Hazen *Technical Memorandum*

Re: East Ocean View Neighborhood Drainage Improvements Master Plan Review

East Ocean View Master Plan Review **FINAL**

Figure 2-1: Supplemental Survey Locations

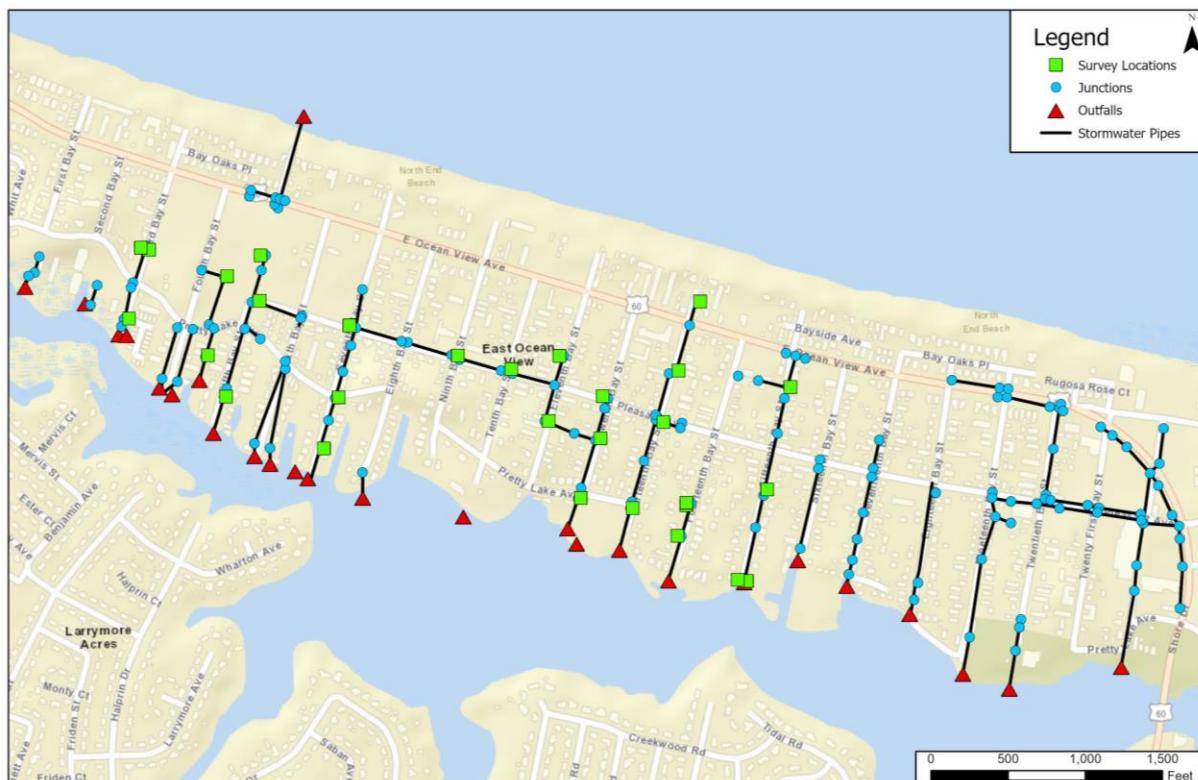
The initial effort was to assess the quality of the model's pipe elevation and sizes and compare them to the City's GIS pipe and manhole values. According to the previous master plan, the City's GIS data was used to populate the hydraulic model with pipe dimensions and elevations. However, the findings revealed the model's elevations were not consistent with the City's GIS data which could be a result of changes made by the previous consultant as part of their scope of work. To confirm the model elevations, Hazen obtained supplemental survey elevations and sizes at the locations shown in **Figure 2-1**. Nearly all of the survey elevations were found to not match the model. As the survey is the most accurate source, these elevations were incorporated into the model and non-surveyed elevations were adjusted to achieve consistent slope between the survey locations. As additional survey becomes available during detailed design phases, the model will continue to be updated.

Figure 2-2: Location of development projects within the project area

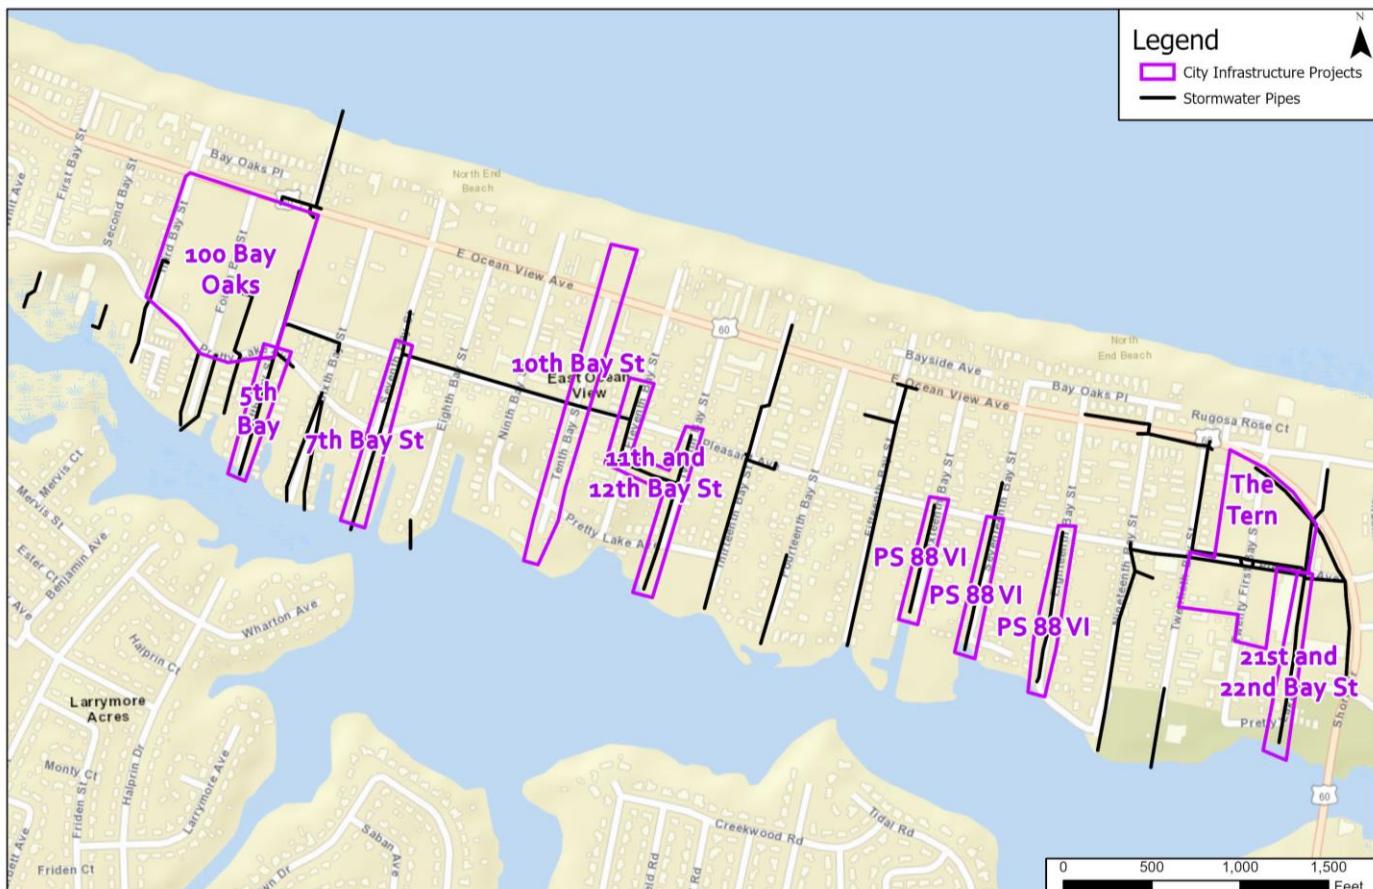
There are a number of development and utility related projects that have been designed and constructed in the basin, the largest being The Tern in the eastern portion of the watershed. These projects, shown in **Figure 2-2**, have not yet been fully reflected in the model as the status of construction is unclear. While design plans were available for several of these areas, the elevations shown on the plans did not match the surveyed elevations obtained to validate the model configuration. As such, the projects with conflicting data were assumed to not yet be fully constructed and survey elevations were utilized. **Table 2-1** lists the current and recent projects within the watershed and their status as of this report. Additional model updates will be included as project completion is confirmed with the City.

Figure 2-3: Existing conditions model results

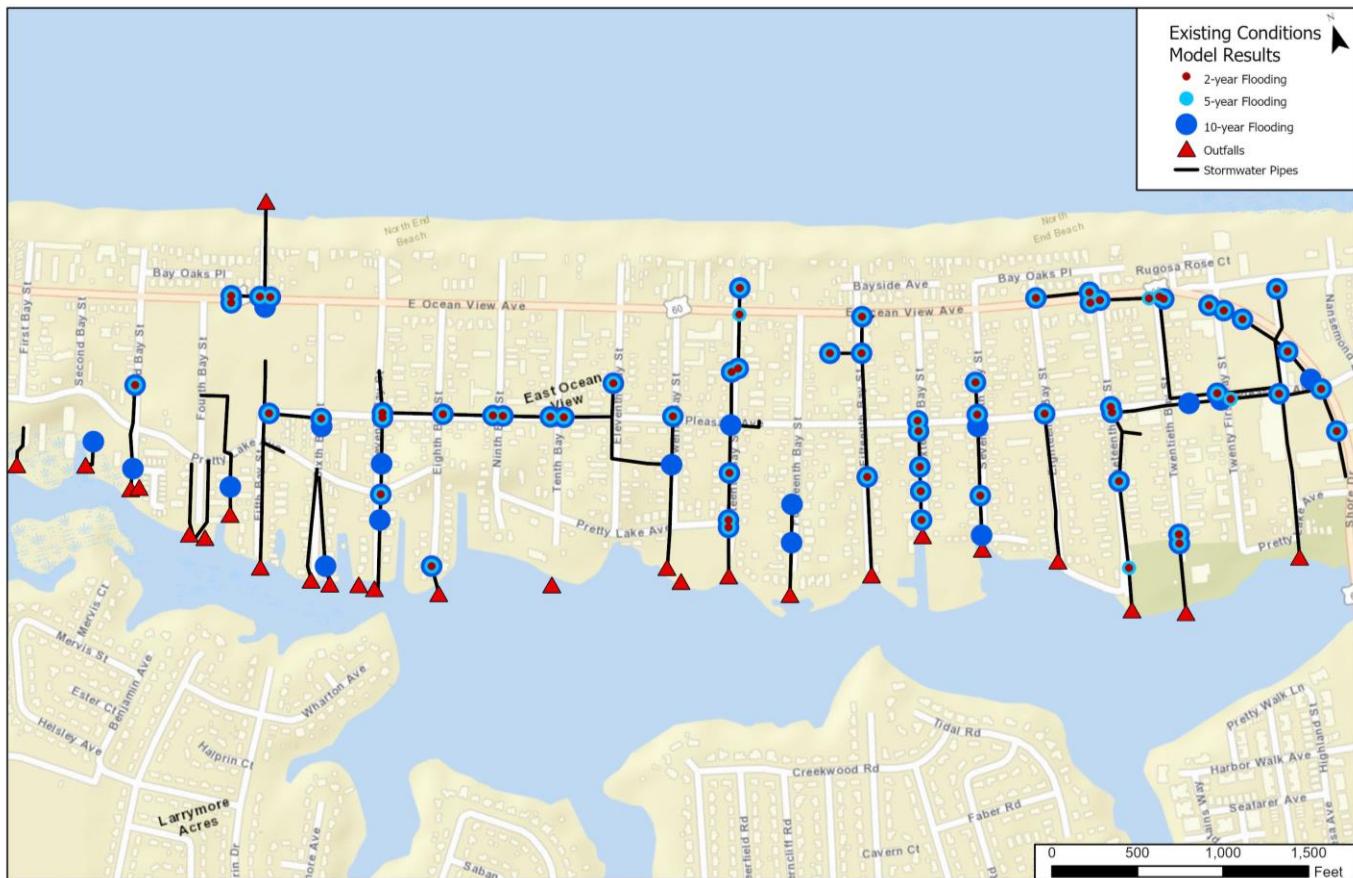
Model results for the updated existing conditions model are shown in **Figure 2-3**. Flooding is seen throughout the project area for many of the design storms which is consistent with the 2013 modeling efforts and the flooding witnessed in the field during rain events. Results for the areas surrounding The Tern and other City projects will need to be reevaluated once these projects have been completed.

The proposed conditions model hydraulic network (which includes the recommended projects) was then connected to the revised delineations as part of this study. The proposed projects continue to greatly reduce the flooding in the project area, even for the 10-year design storm. Additional investigation will be needed to confirm that the recommended projects are feasible given cover limitations and utility conflicts.

Figure 3-1: Proposed Phasing Plan

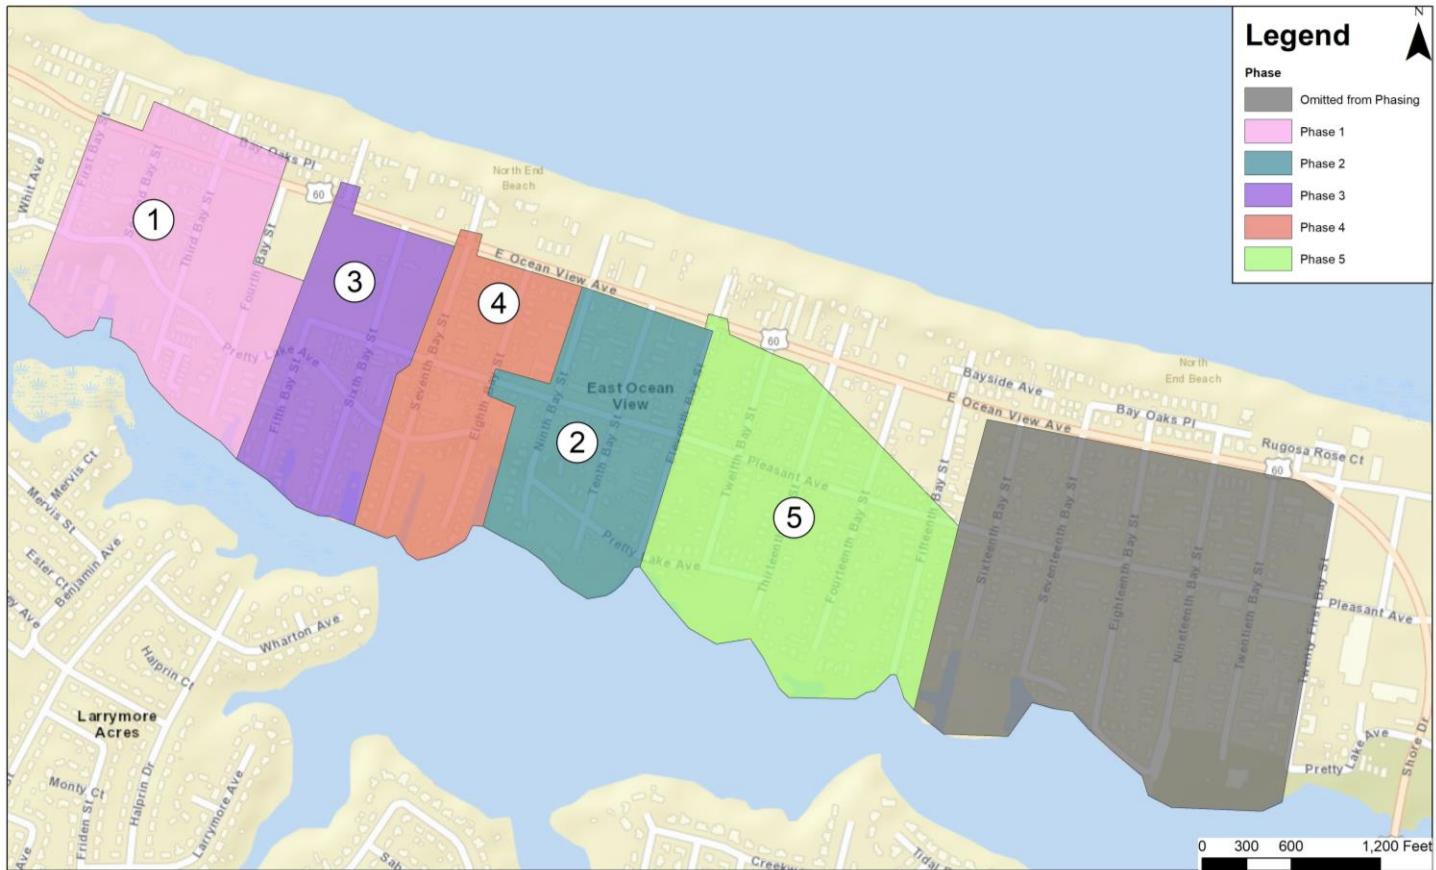
Phasing boundaries were selected to generate phases with similar construction costs over the five-year overall project duration. For clarity of the phasing map, the phasing boundaries drawn in **Figure 3-1** include areas of recent development and improvement. These areas of recent development will be avoided as much as possible during design via records research and field visits to avoid repeated disturbance within the right-of-way. The proposed phasing plan is shown in **Figure 3-1** below.
